GRUNT/CREAK/CHIRP/SQUEAK NOISE FROM THE FRONT LOWER CONTROL ARM OVER BUMPS

TSB 13-9-3

FORD:
2011-2014 Mustang

The article supersedes TSB **13-7-8** to update the Service Procedure and Part List.

Figure 1 - Article 13-9-3

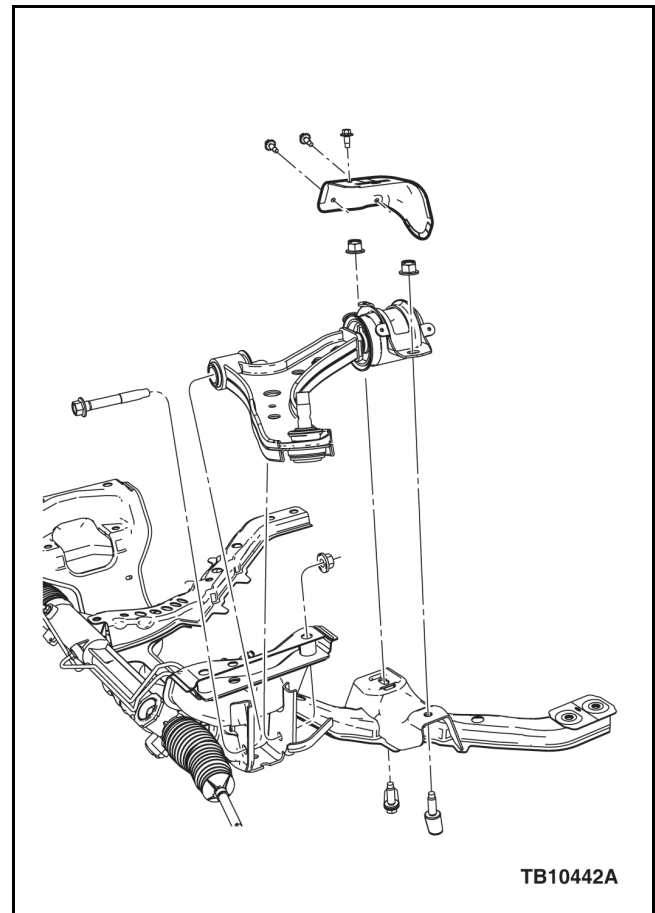
Some 2011-2014 Mustangs vehicles may exhibit a grunt/creak/chirp/squeak noise from the front lower control arm hydro bushing. These noises may occur over large vertical bumps like speed bumps, pot holes, rough roads and driveway approaches.

1. Attach Rotunda wireless chassis ears (JSP97202) or equivalent on both lower control arm hydro bushing bracket tabs to verify noise is coming from the hydro bushing.
 - a. The hydro bushing is the large diameter bushing at the rear of the control arm. Due to hydraulic fluid flow some noise from the bushing is normal. There would typically be some difference from side to side on a unit with a noisy control arm.
2. If the noise is not confirmed as coming from the hydro bushing, this article does not apply, refer to Workshop Manual (WSM), Section 204-00 for normal diagnostics.
3. If the noise is confirmed as coming from the hydro bushing, replace the affected lower control arm with the new lower control arm with shield and three (3) screws. Tighten the three (3) shield screws to 7 N•m (62 lb-in.) Refer to WSM, Section 204-01. (Figure 1)
